Subject: Docket No. 50-206
ATWS Mitigation System Isolation Devices
San Onofre Nuclear Generating Station
Unit 1

By letter dated April 5, 1989, the NRC requested additional information regarding the qualification and testing of isolation devices that will be used in the San Onofre Unit 1 ATWS Mitigation System. These devices will also be used in the Safety Parameter Display System. Enclosure 1 provides SCE's responses to the four specific questions asked in your April 5, 1989 letter.

The following provides SCE's responses to the four specific questions/comments from the NRC's April 5, 1989 letter regarding the qualification and testing of isolation devices that will be used in the San Onofre Unit 1 ATWS Mitigation System and the Safety Parameter Display System.

FIGURE 1

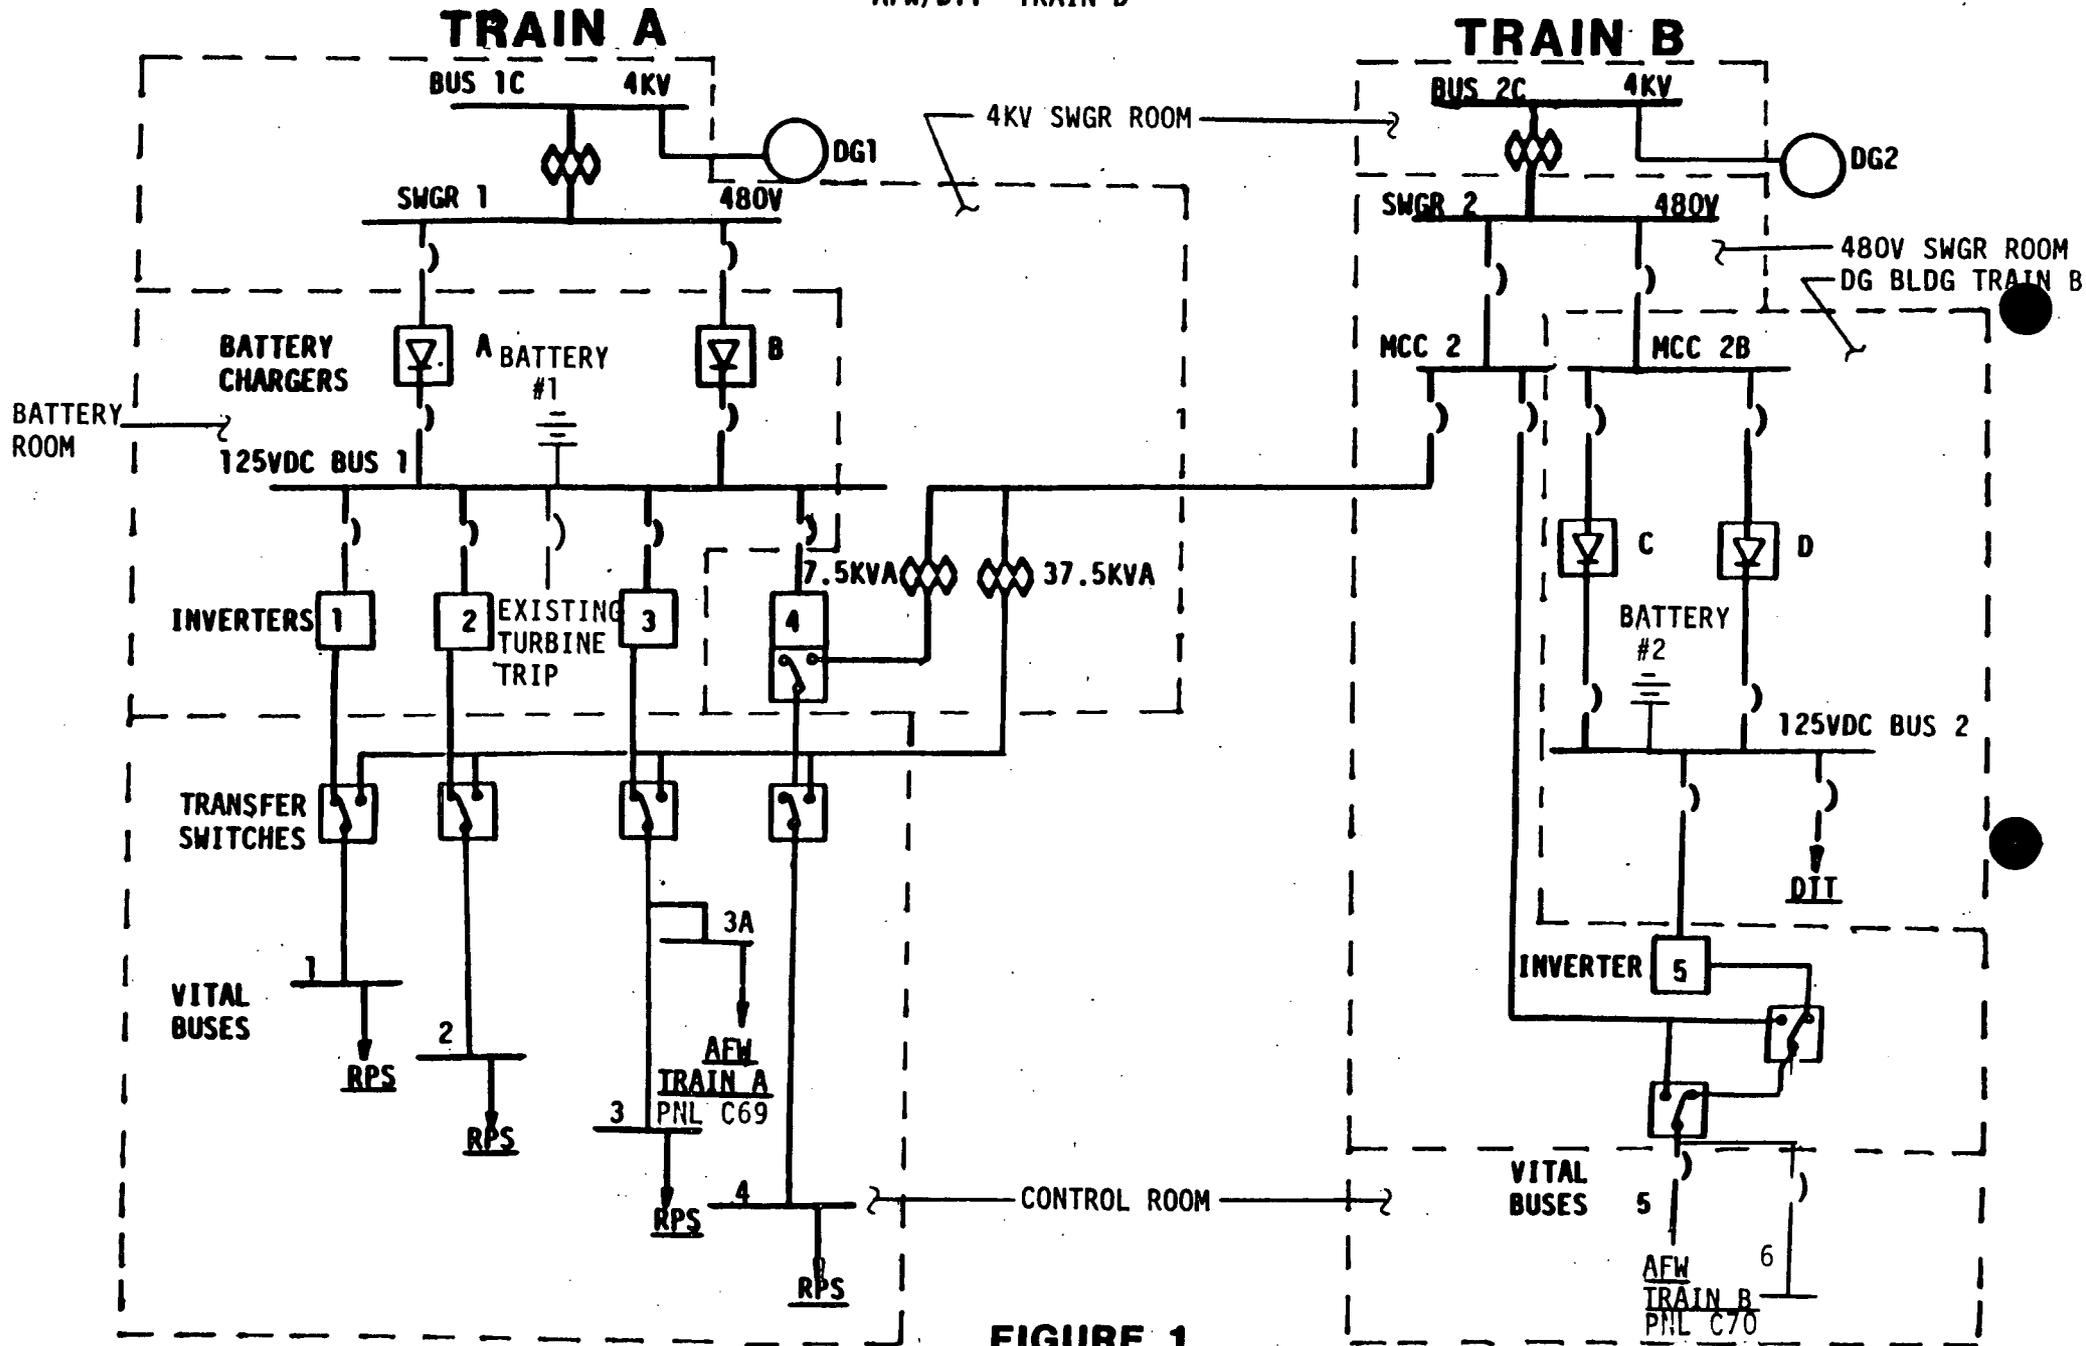
4. The electrical and physical separation of power between AFWS-Train "B"/DTT from RPS is not clear from the data provided. DWG 5146828-25 does not address the DTT power source nor does it show the tie-in for the 125 VDC Bus 2. Breakers 8-11B26 and 8-12B26 are not shown. Please provide the necessary information.

Figure 1 provides a simplified electrical distribution diagram depicting the electrical and physical separation of the Train A and Train B power supplies to the RPS/AFW Train "A" and the AFW Train "B"/DTT circuitry. The battery chargers for DC Buses #1 and #2 were recently repowered (train aligned) during the Cycle X outage. The specific 125 VDC Bus 2 breaker position for the DTT circuitry has not been identified at this time.
